GRACE HEBERT CURTIS ARCHITECTS, LLC | 501 GOVERNMENT STREET | SUITE 200 | BATON ROUGE, LOUISIANA 70802

ADDENDUM #001

BRCC Bonne Sante Locker Room Renovation 201 Community College Drive Baton Rouge, Louisiana 70806 GHC Project No. 3122113

2 ENLARGED ELECTRICAL LIGHTING PLAN - WOMEN'S LOCKER ROOM

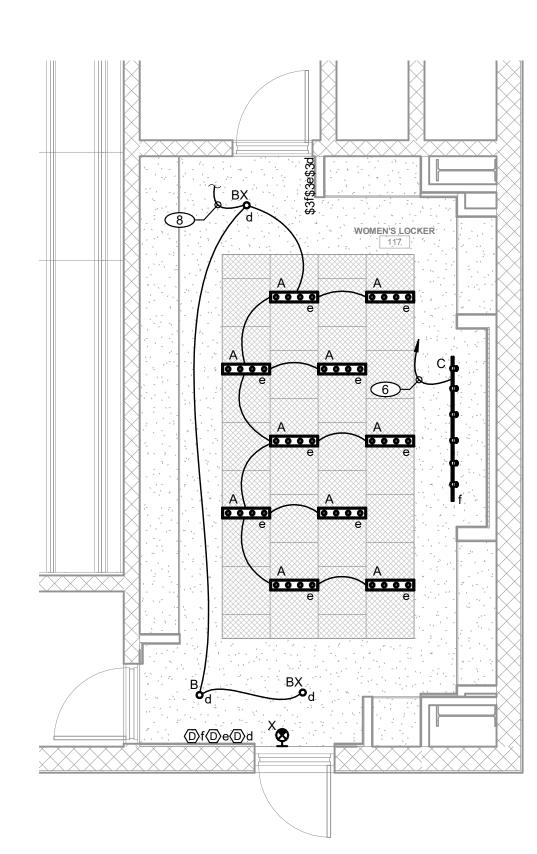
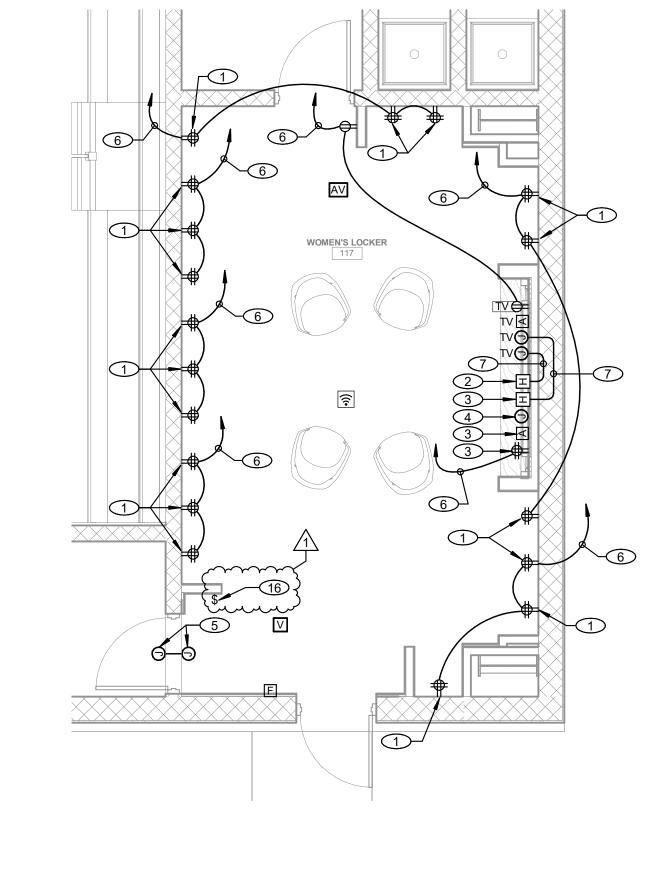
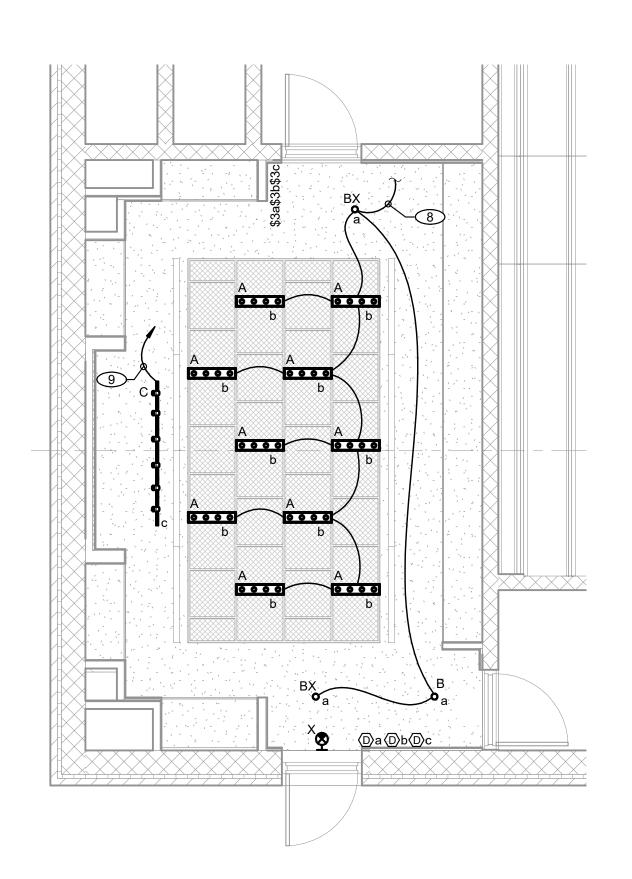
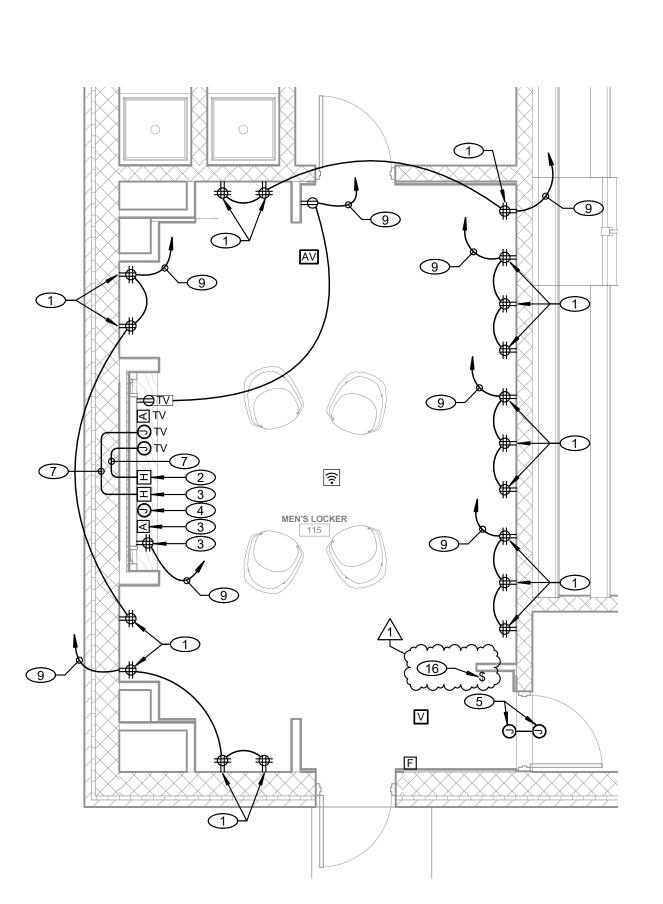
- a. Yes these devices are to be located behind owner provided screen. Refer to 7/A403.
- 17. Will there be light switches to control the locker puck lights, or LED under locker lighting? Will there be any switch or control on the fan system in the lockers?

- a. To be addressed in Addendum in electrical drawings. Quad outlets behind each locker to be labeled and the plug in that will be used for the light drivers to be split off. Designated light outlets will run back to the one switch in the room adjacent to the door.

- 1. Locate in the ceiling soffit as required for each of the locker's integrated power and LED lighting system (verify exact location in advance). Obtain installation instructions in advance from the lockers manufacturer and provide all work described therein. Reference all associated architectural details, and provide all required work ascordingly. Connect half of this quadraplex receptacle as required to be controlled by the lighting control toggle switch indicated by Referenced Electrical Note No. 16, and plug the power cord for the locker-integral lighting fixture and ventilation fan into the "controlled half" of the quadraplex receptacle.

- 16. Locate as required for control of the lockers' integral, LED, lighting fixtures and ventilation fans. Verify exact desired location in advance with the architect. See Referenced Electrical Note No. 16.
